**Helena Township
Board of Supervisors Quorum
Attendance at New Prague Planning Commission Meeting
7/22/2026 | New Prague City Hall | 6:30 p.m.**

MEMORANDUM

SUBJECT: CONCEPT REVIEW OF HARVEST FIELDS SINGLE FAMILY RESIDENTIAL DEVELOPMENT CONSISTING OF 185 LOTS ON 63.05 ACRES ON LAND GUIDED AS R1 SINGLE FAMILY RESIDENTIAL AND RM MEDIUM DENSITY RESIDENTIAL, AS PROPOSED BY JPB LAND, LLC, APPLICANT.

DATE: 7/16/2026

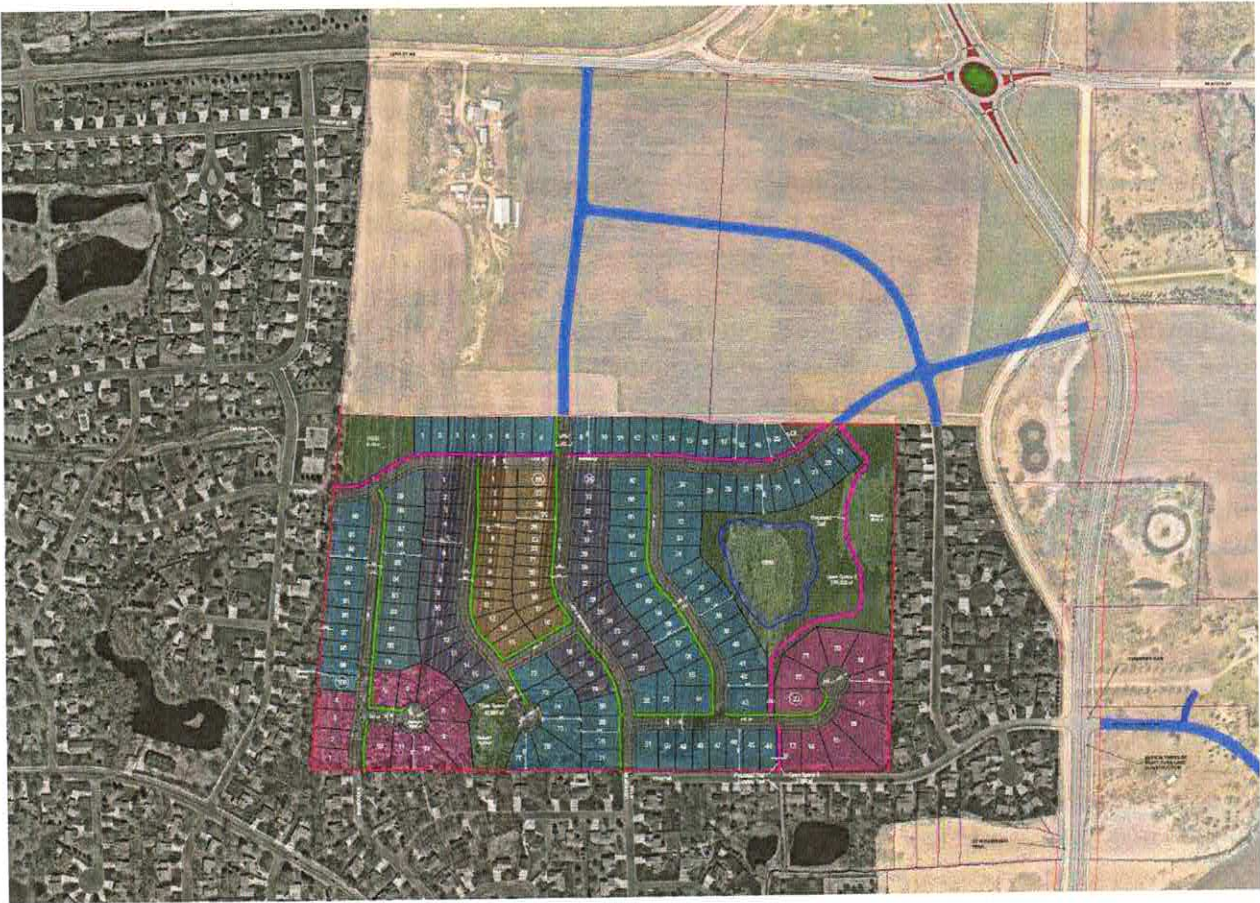
Absent having a traffic impact study completed at this time, staff makes a general observation that the connections to existing Ironwood Ave. NE and Ladyslipper Ave. NE are required connections as well as Bohemia Street NE. Staff notes a general lack of alternate roadway connections to the property to the north, however, the traffic impact study will provide more insight into this topic.

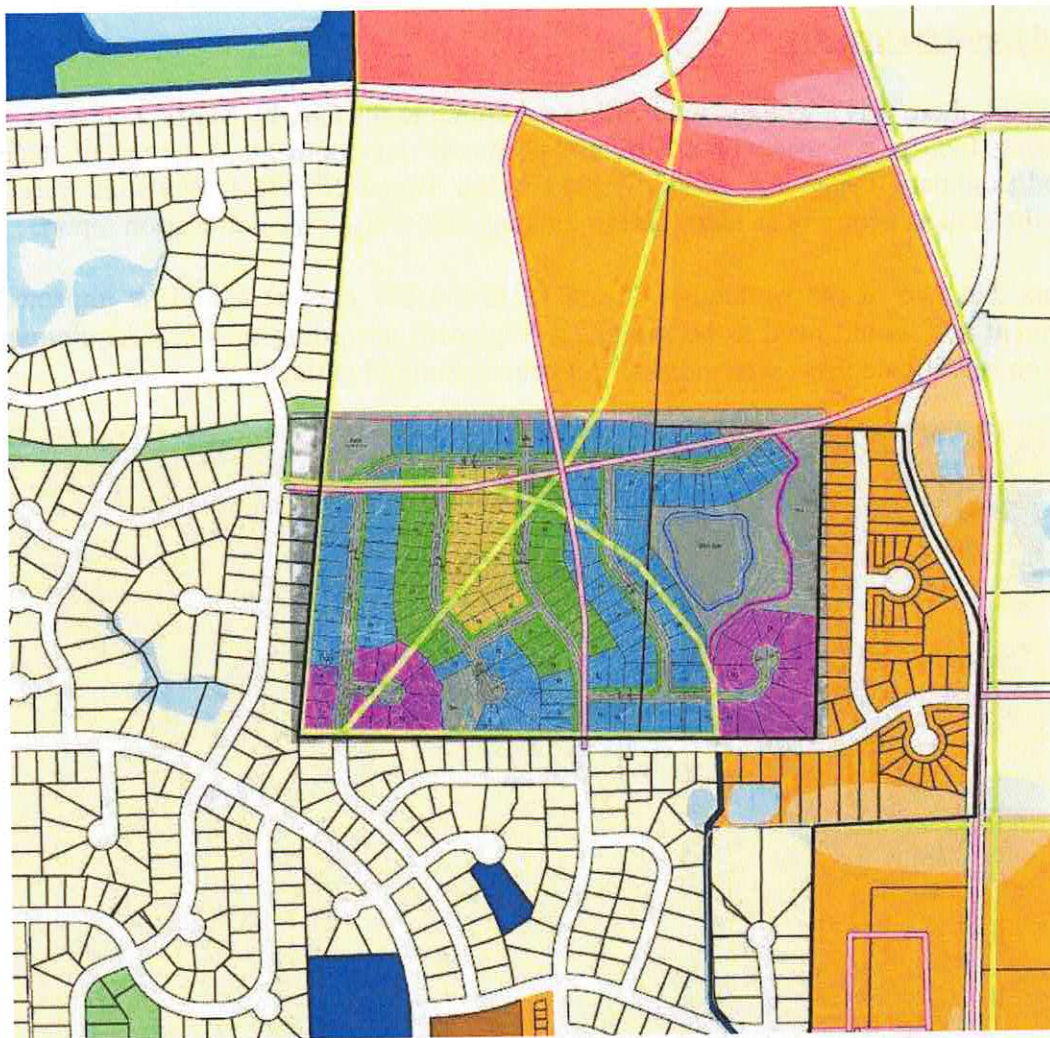
The map below shows the minor collector roads in the city's transportation plan overlaid on the proposed development along with a general connection of the Greenway Trail through the development to connect at Heritage Park. Not shown on this map is a secondary trail from Ironwood Ave. NE north to 12th Street NE. All trails shown are simply identified as "potential" in the comprehensive plan and are not specific requirements. Staff supports the greenway's proposed continuation into the concept development and interim solution of providing connectivity east to

Heritage Park via a trail adjacent to Bohemia Street SE, but notes that the greenway trail must continue through future development of land to the north and ultimately back to Heritage Park.

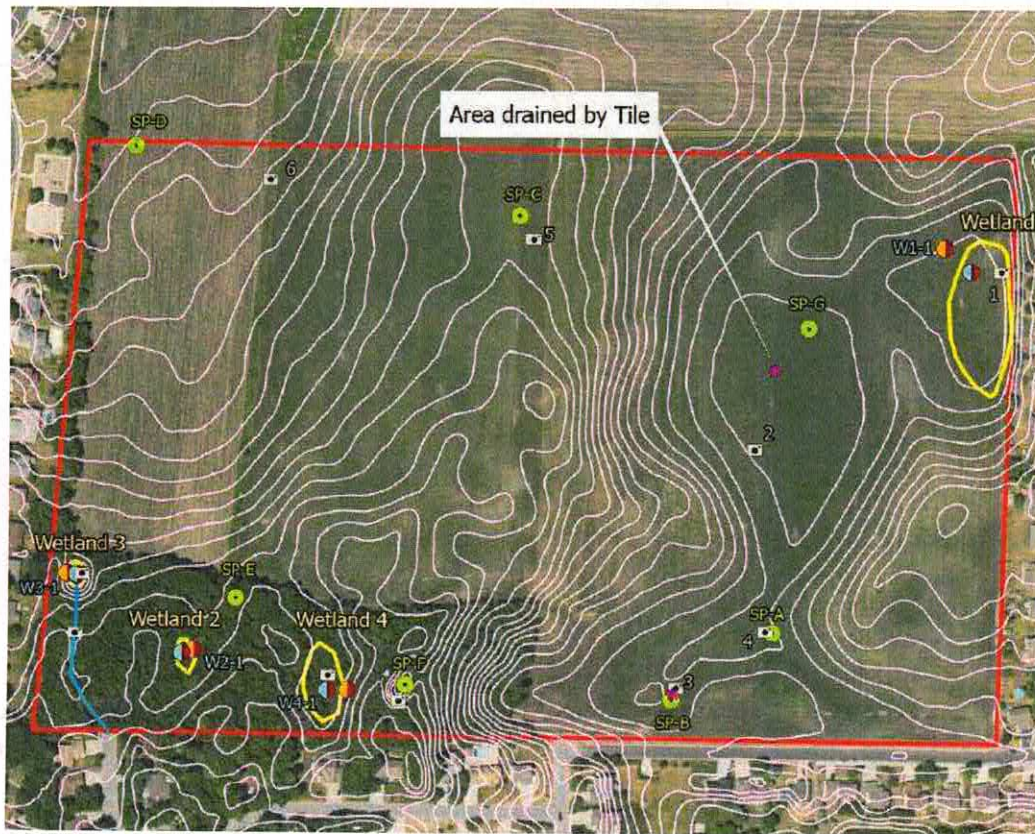
In June 2024, there was a wetland delineation submitted to the City by Marty Anderson of Moore Engineering Inc. as a portion of a different proposed development. A notice of decision for “Wetland/Boundary Type” was issued by the City on August 5th, 2024. Wetlands were found to exist on the subject property as identified in the map below from the delineation report.

It appears that two of the wetlands (#2 and #3 in the SW corner) would be impacted by the development and would need to be mitigated (replaced) according to WCA requirements. An application to mitigate these wetlands has not been submitted at this time.
